Accessibility Survey

City of Downey Hall Road - Lakewood Boulevard To Woodruff Avenue

Date of Inspection
12/8/2016

Disability Access Consultants

Sidewalks : 60X60 Turn Area

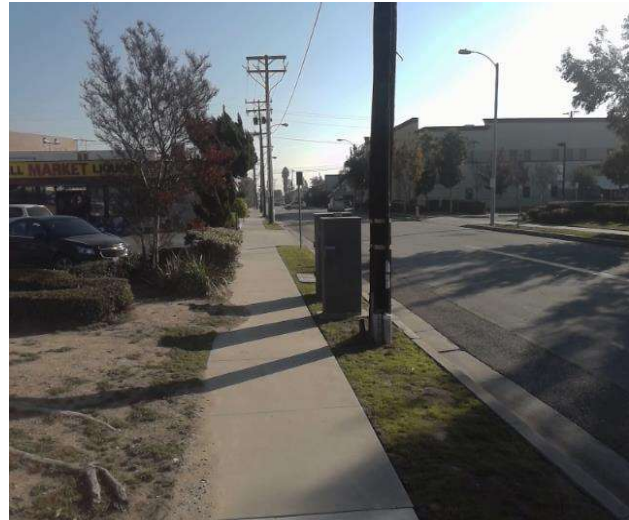
There is no 60X60 turn area at every 200 feet.

On-Site Finding Not Found

Provide a 60X60 turn every 200 feet on the sidewalk.

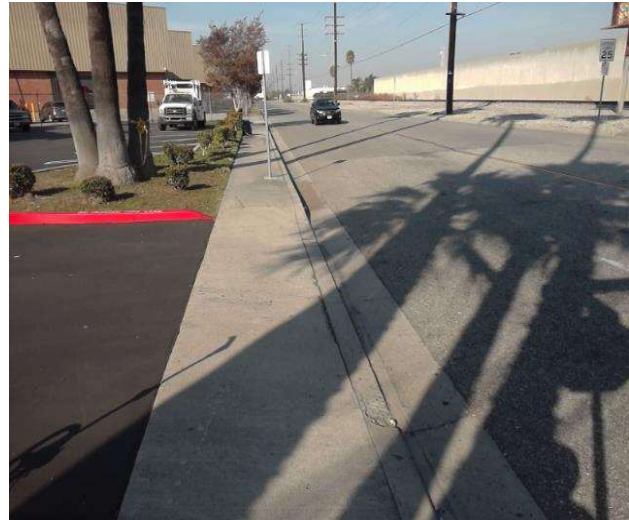
Cross slope at vehicular traffic is not compliant.

On-Site Finding 14.00 percent

Repave the surface to provide a compliant cross slope.

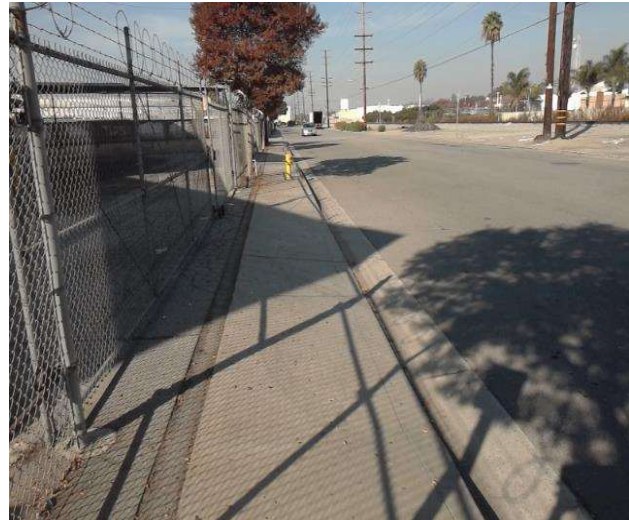
There are no detectable warnings where the pedestrian route crosses vehicular traffic.

On-Site Finding Not Found

Provide detectable warnings.

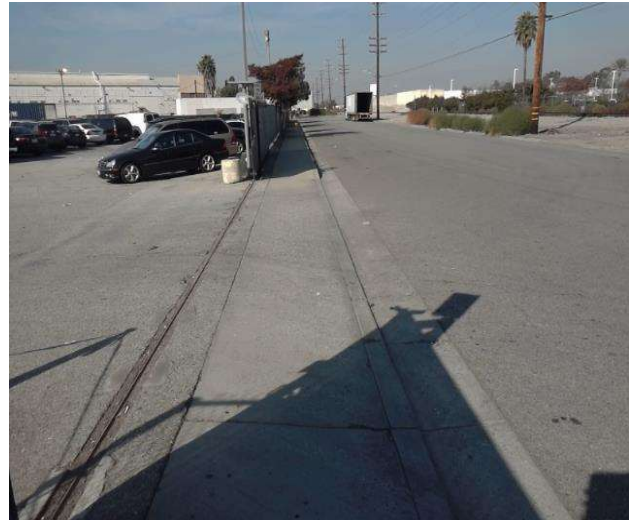
There are no detectable warnings where the pedestrian route crosses vehicular traffic.

On-Site Finding Not Found

Provide detectable warnings.

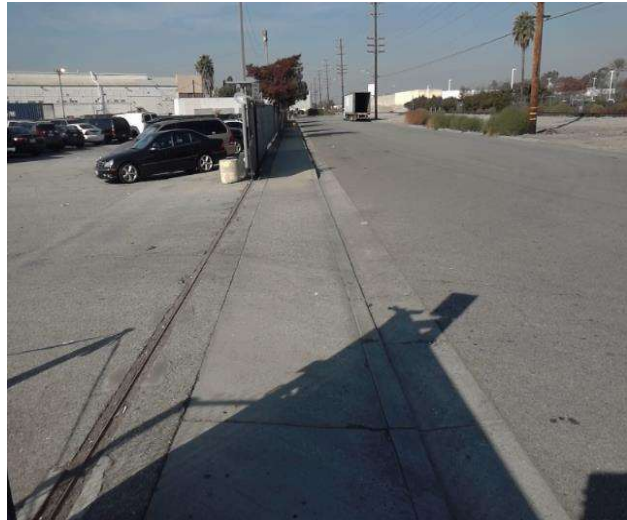
Cross slope at vehicular traffic is not compliant.

On-Site Finding 12.70 percent

Repave the surface to provide a compliant cross slope.
